**R44-series Fixed Floats Skid Extension Upgrade Installation Kit Instructions**

*This kit is for first-time replacement of discontinued C945-1 (LH) & C945-2 (RH) Extension Assemblies, which are replaced by C945-13 (LH) & C945-14 (RH) Lightweight Extension Assemblies.*

**FIGURE 1**

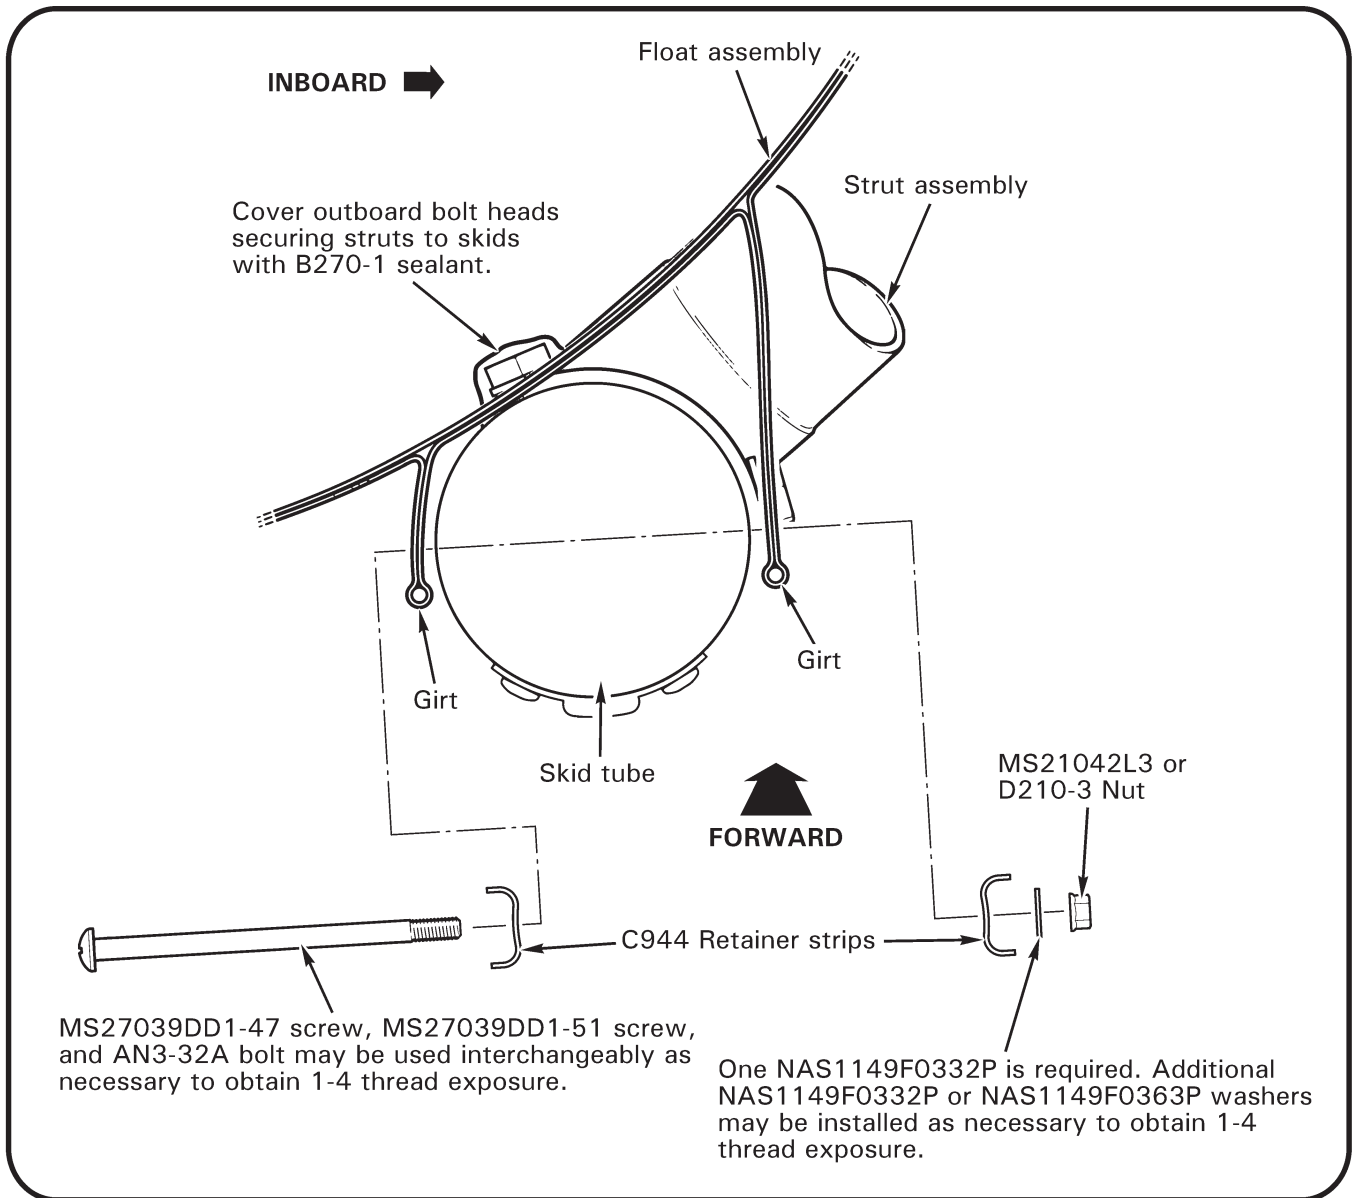
11. Refer to Figure 1. Align holes in C944 retainer strips, float covers, float girts, and skid extension. Select installation hardware as required to achieve 1-4 threads exposed beyond nut; replace two aft-most installation hardware with (2) MS27039C1-08 screws and (2) MS27039C1-07 screws per Figure 2. Seal under head & nut, and around MS27039DD1-47 or -51 screw or AN3-32A bolt between girt & skid tube with B270-1 sealant. Special torque hardware to 25 in.-lb wet with A257-9 anti-seize (threads only).
